Addendum #3

Bid Opportunity: 25-7693-RFT - Elmira District Secondary School Weight Room Renovation Closing Date: Thursday, March 20, 2025 2:00 PM

WRDSB-Elmira District Secondary School Weight Room Renovation
WRDSB Project No.: 25-7693-RFT
WF Project No.:2022-0277-15

March 13, 2025
ADDENDUM #3
Page 1 of 2

5 SITE PLAN PARTIAL RENOVATION PLAN
A101 Scale: 1 : 250

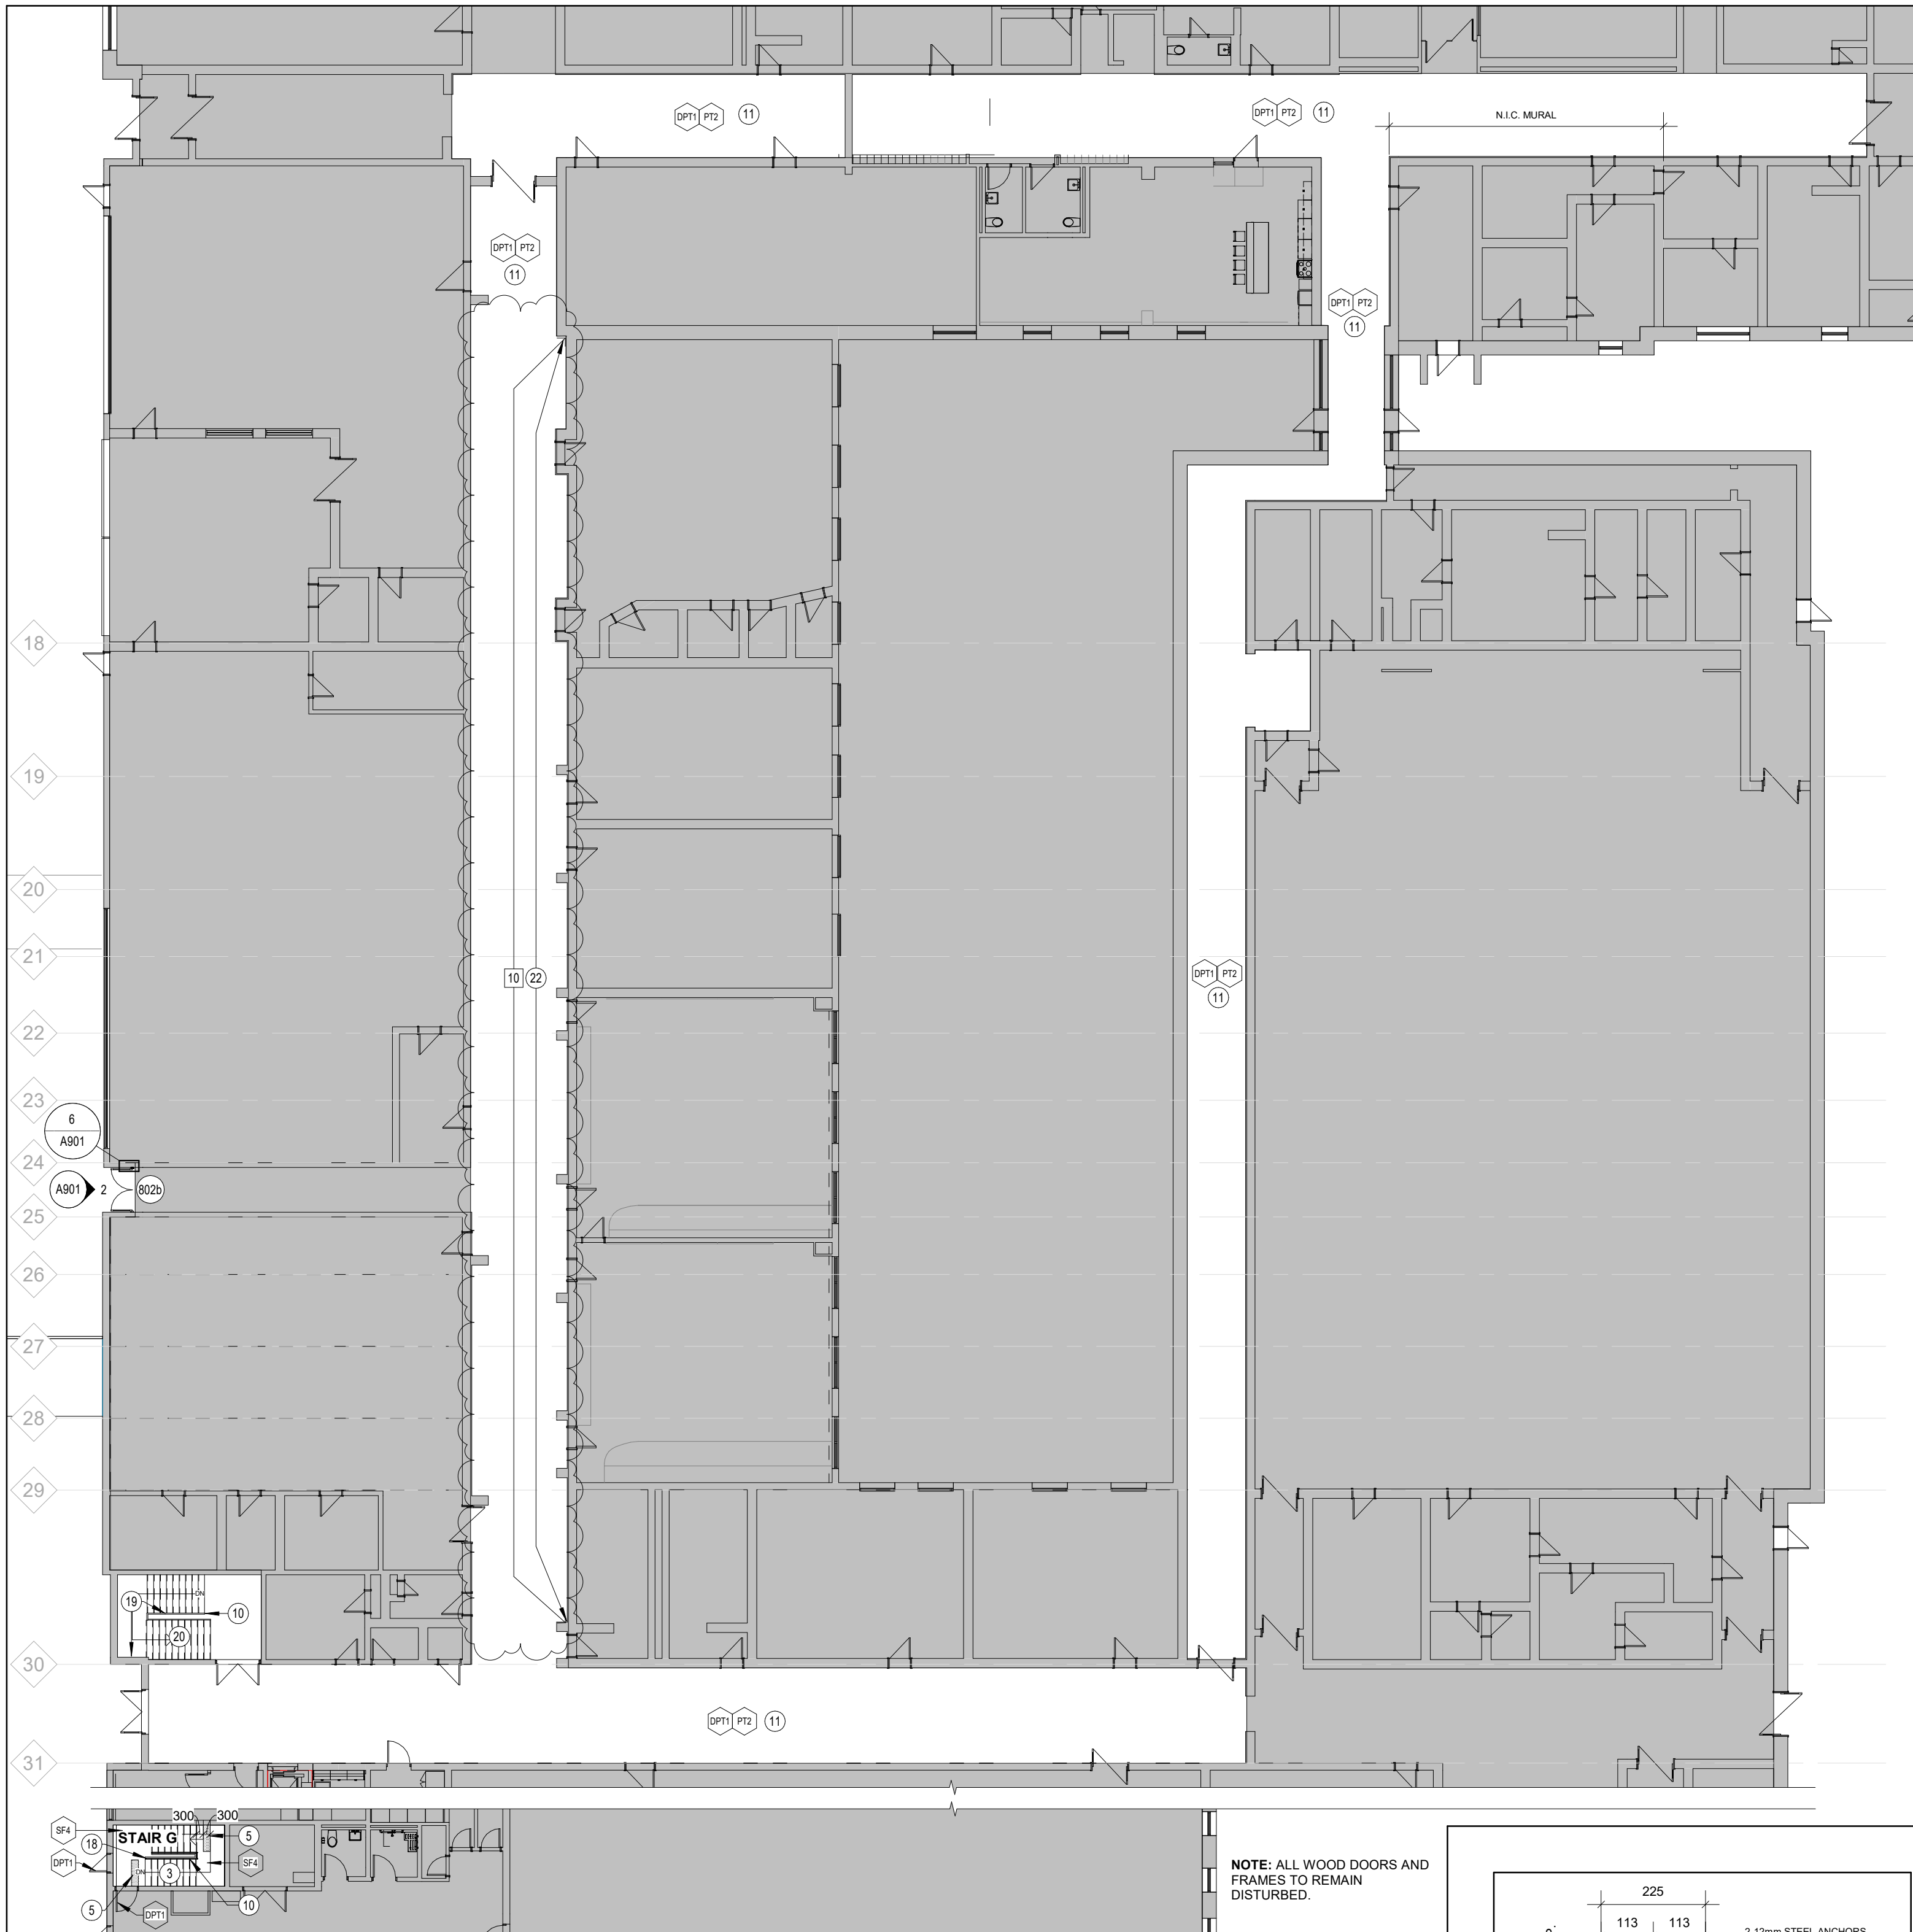
A101

1. Bike racks added to 5/A101

A201

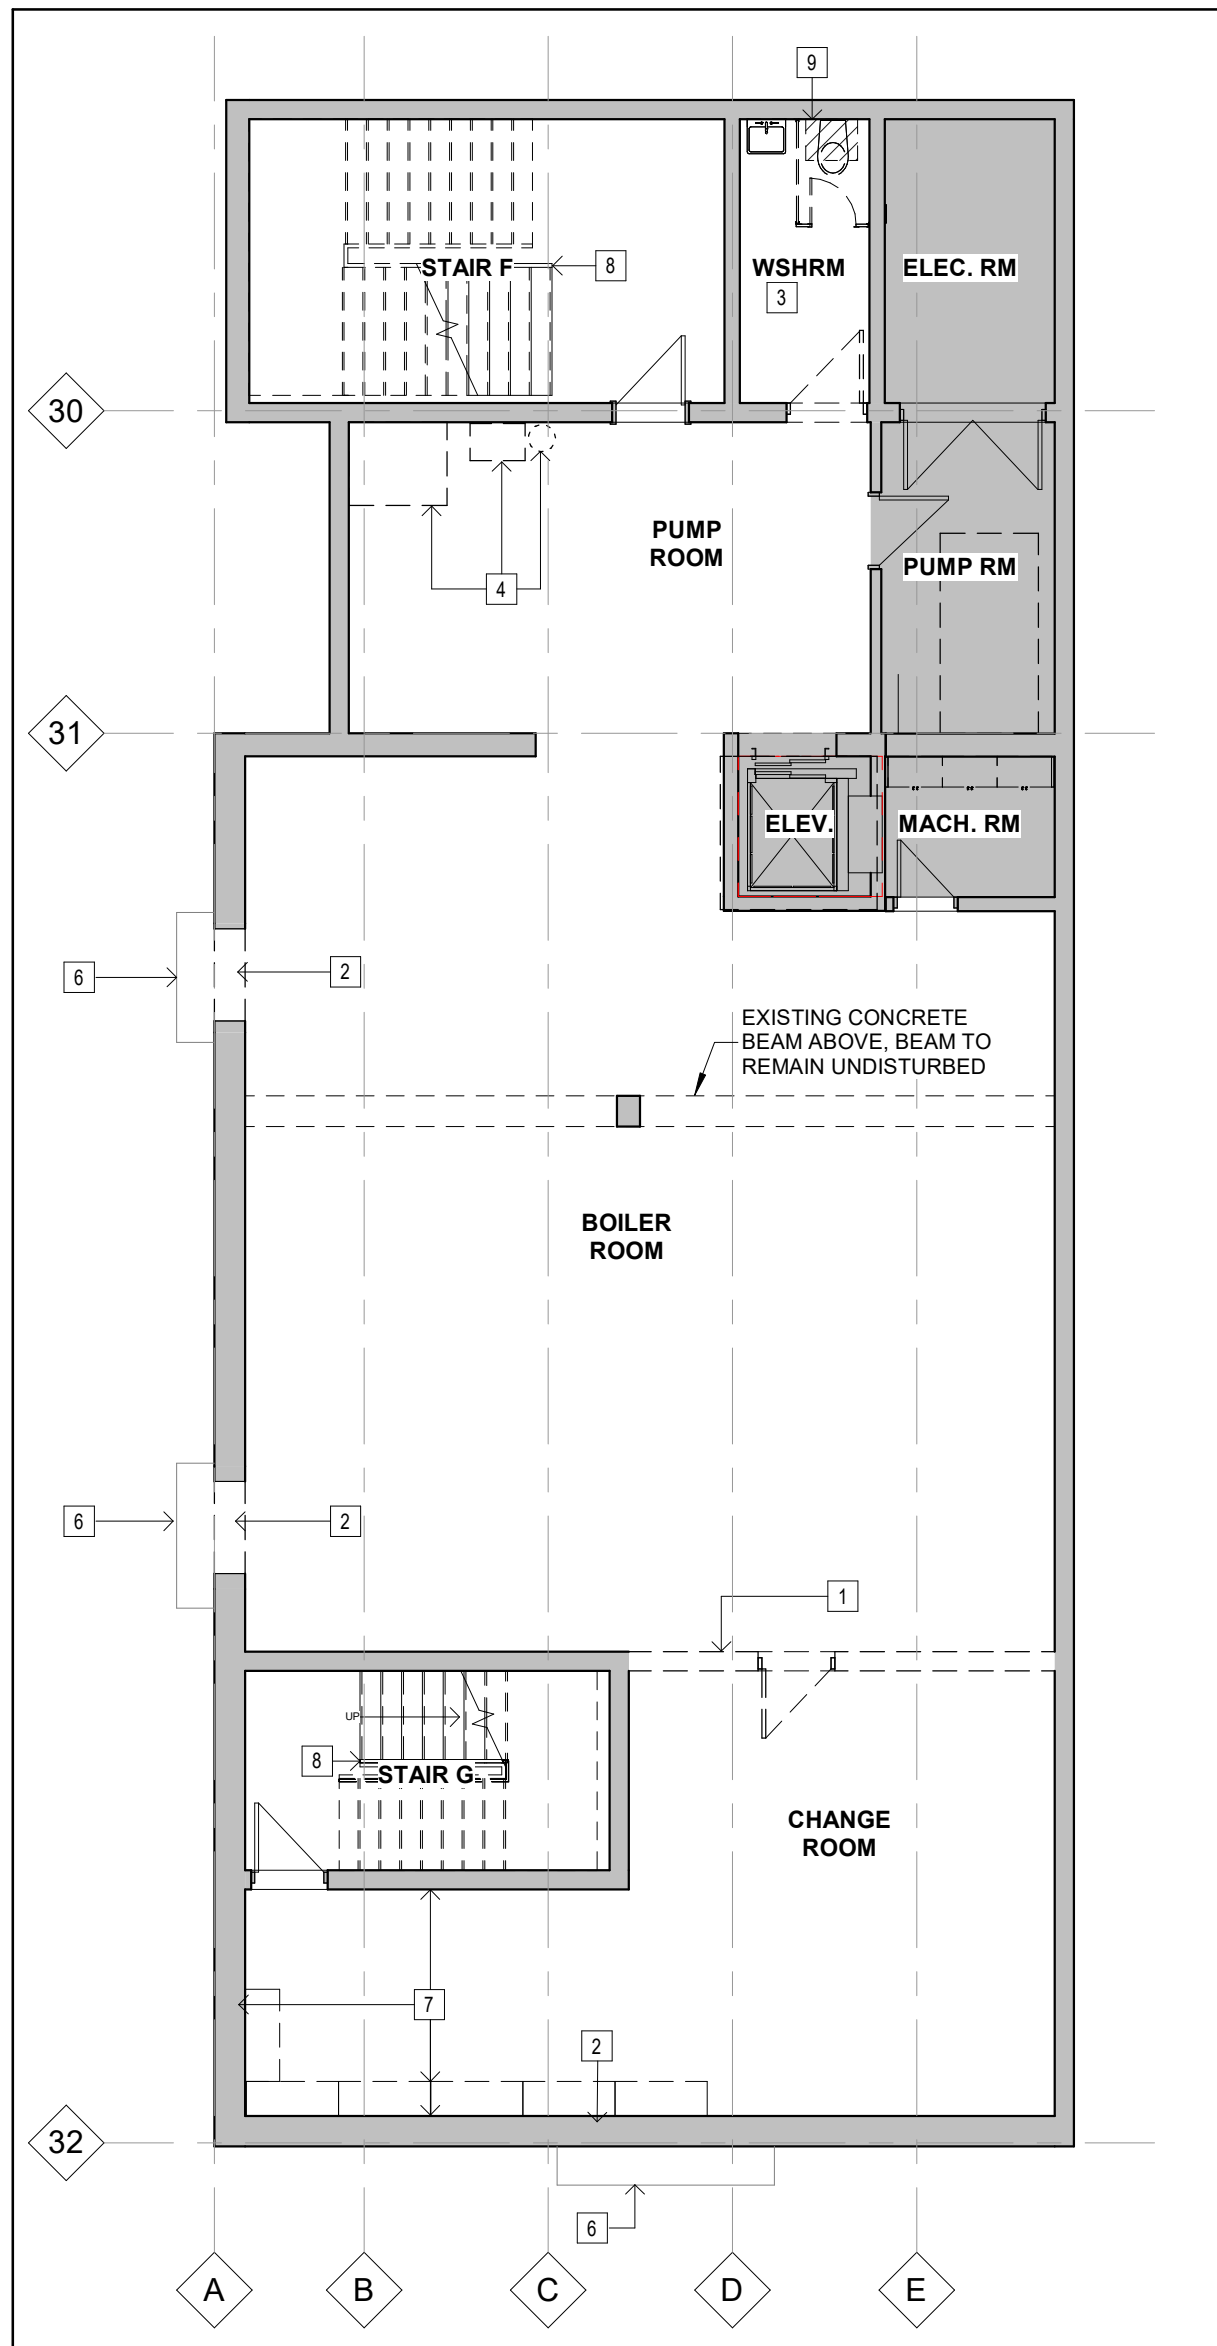
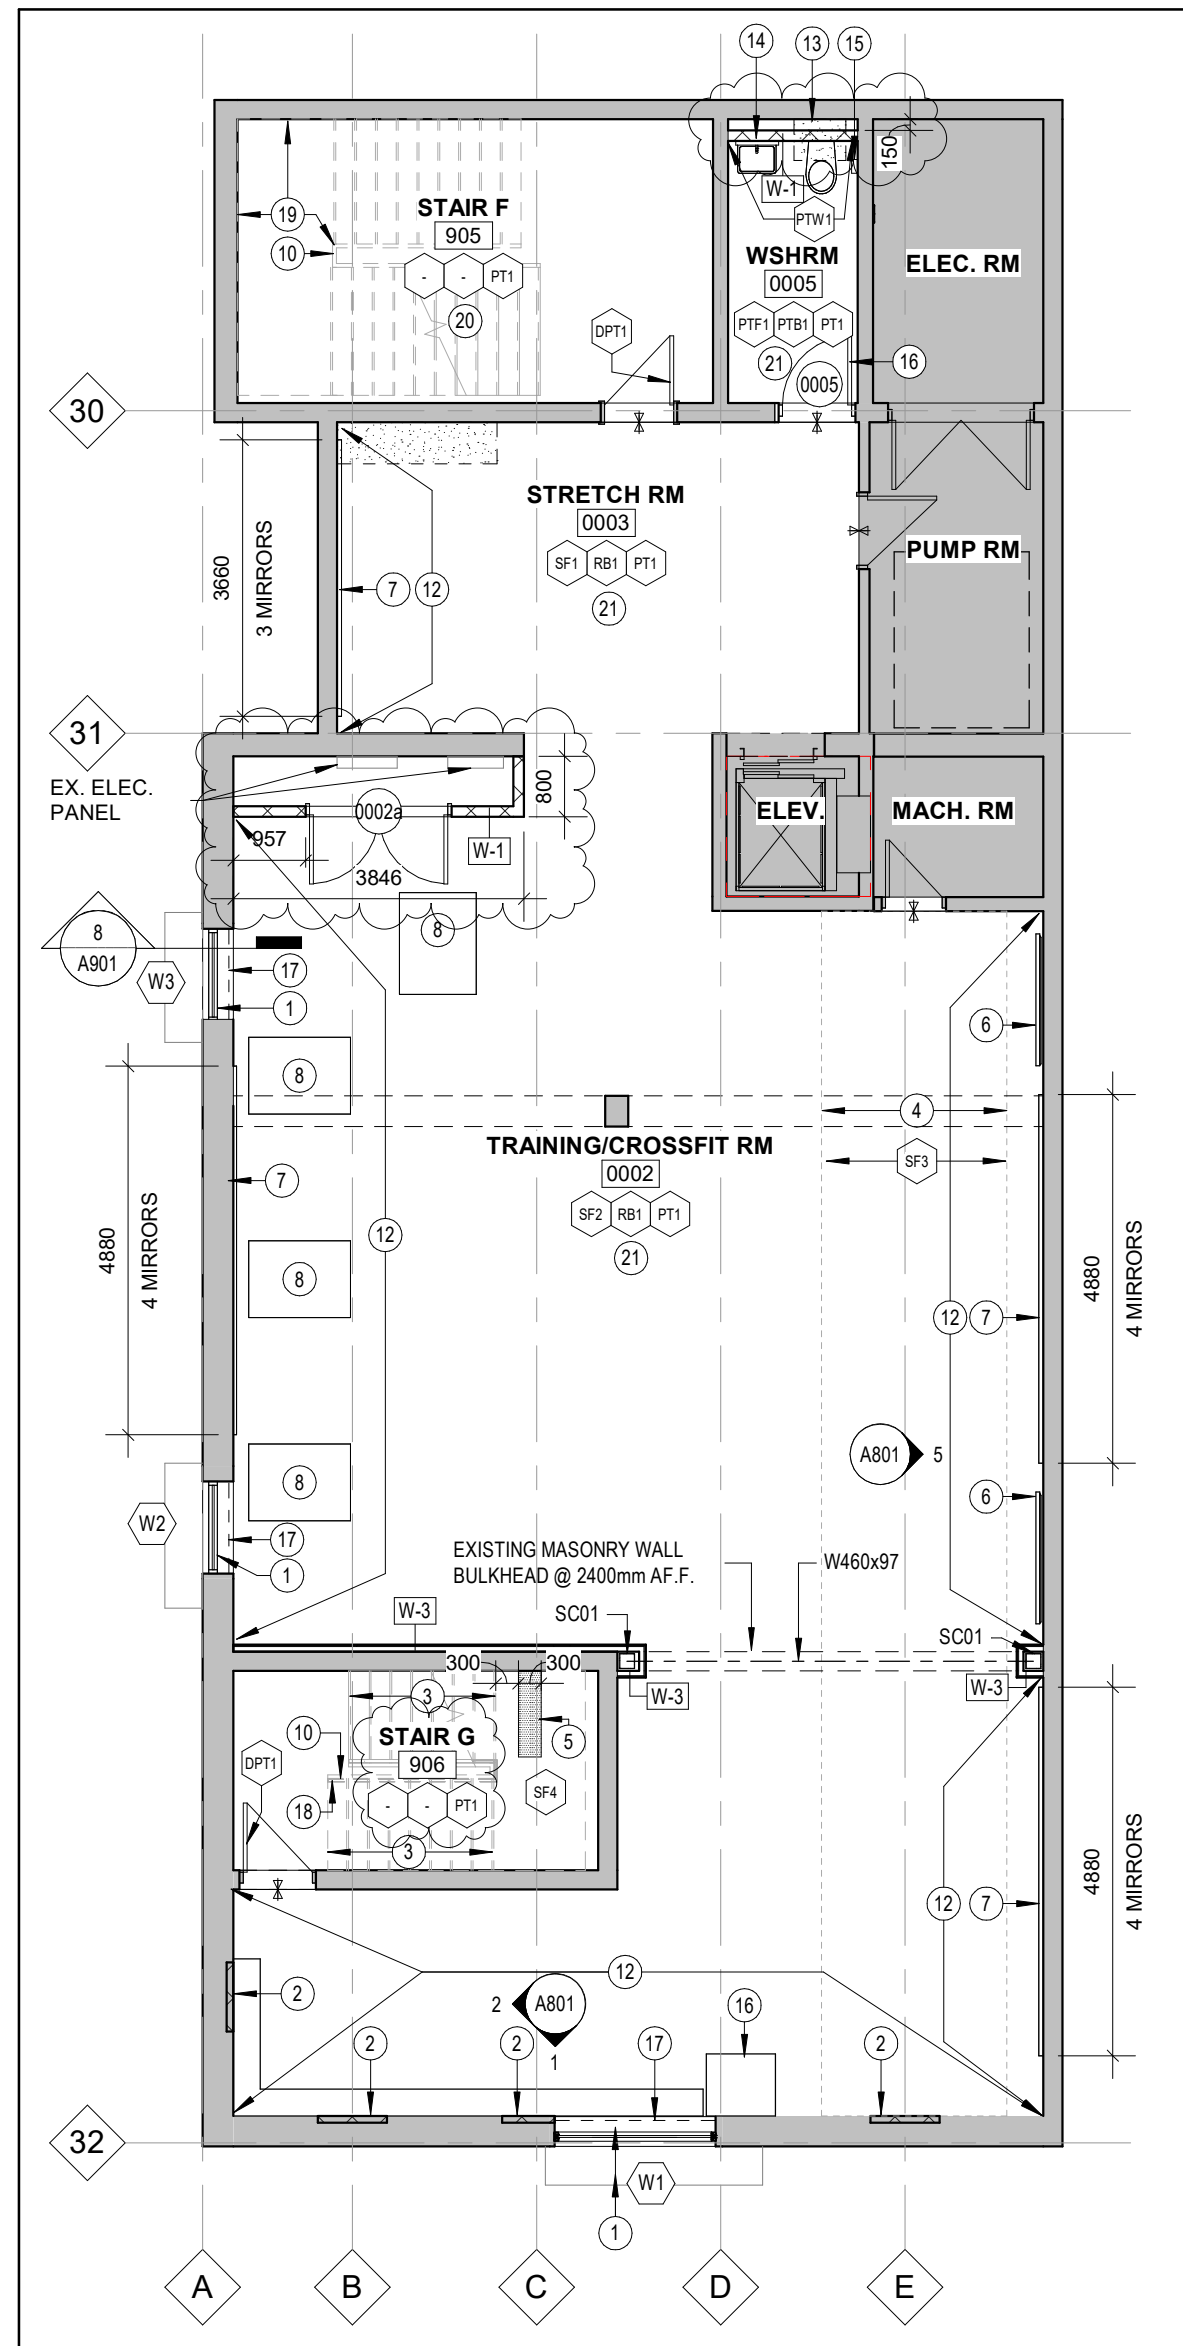
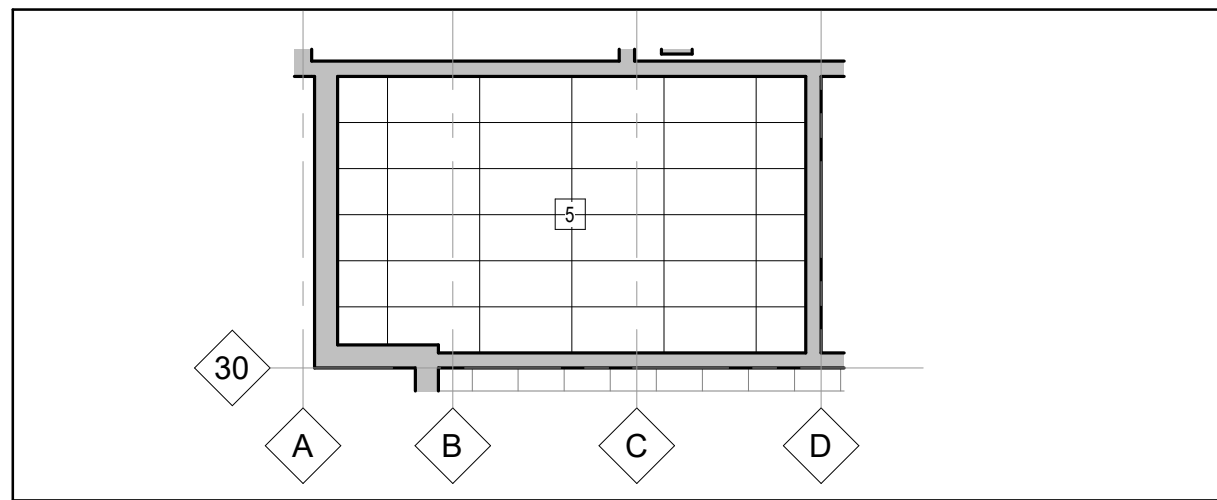
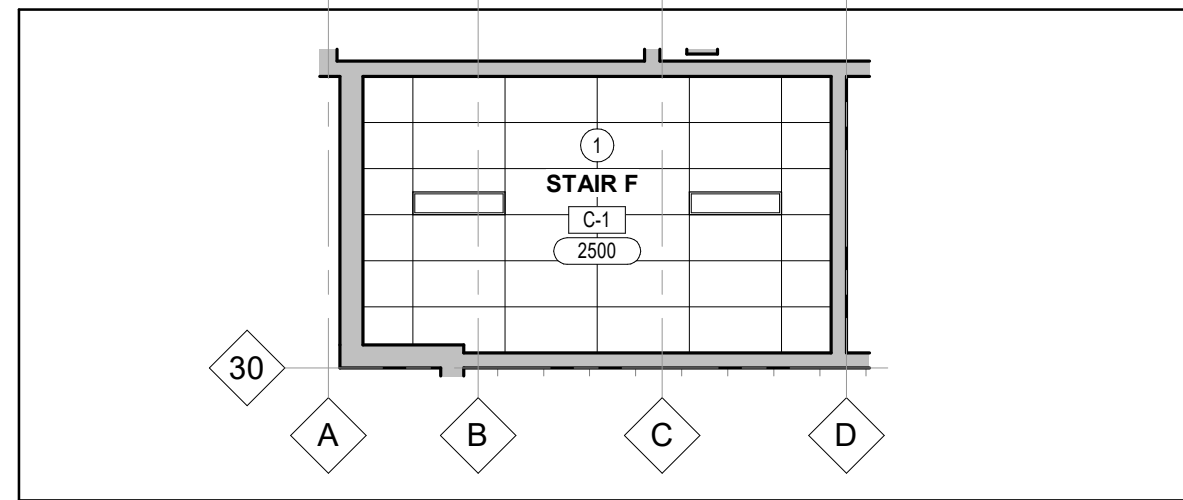
Question 3:

Please confirm that the lockers are not included in the hallway painting. It is also noted that doors are to be painted. Please confirm wood doors are not included. Also, based on site photos, there are a lot of accessories, frames, boards on the wall in the hallways. Drawings note that part of the scope is to remove and re-install all frames, tackboards, accessories. Will space be given to store all these materials?

Question 4:

A201 notes a W-1 masonry assembly. We cannot find where this applies to. Can you please advise?

A201

1. Add demolition note 10 to read "Remove and dispose of existing locker doors, pans and hooks. Prepare interior of lockers to receive new paint."
2. Add drawing note 22 to read "Provide new locker doors, pans and hooks. Paint interior to match existing. GC to confirm quantity."
3. In Wall Assemblies revise W-1 to read "140 Concrete Block".
4. In Wall Assemblies revise W-2 to read "Reserved".
5. Add "PT1" to Stair G

Answer 3:

See attached A201 for extent of interior locker painting, the rest of the lockers are to remain undisturbed. Wood doors and frames are to remain undisturbed. Yes there will be space for storage, owner to provide on site storage for all frames, tackboards and accessories.

Answer 4:

See attached for revised Wall Assemblies.

- REMOVE EXISTING VINYL HANDRAIL CAP. PREPARE SURFACE TO RECEIVE NEW VINYL RAILING CAP.
- REMOVE CONCRETE. REFER TO TRENCHING LEGEND.
- REMOVE AND DISPOSE OF EXISTING LOCKER DOORS, PANS AND HOOKS. PREPARE INTERIOR OF LOCKERS TO RECEIVE NEW PAINT.

- PROVIDE NEW LOCKER DOORS, PANS AND HOOKS. PAINT INTERIOR TO MATCH EXISTING. GC TO CONFIRM QUANTITY.
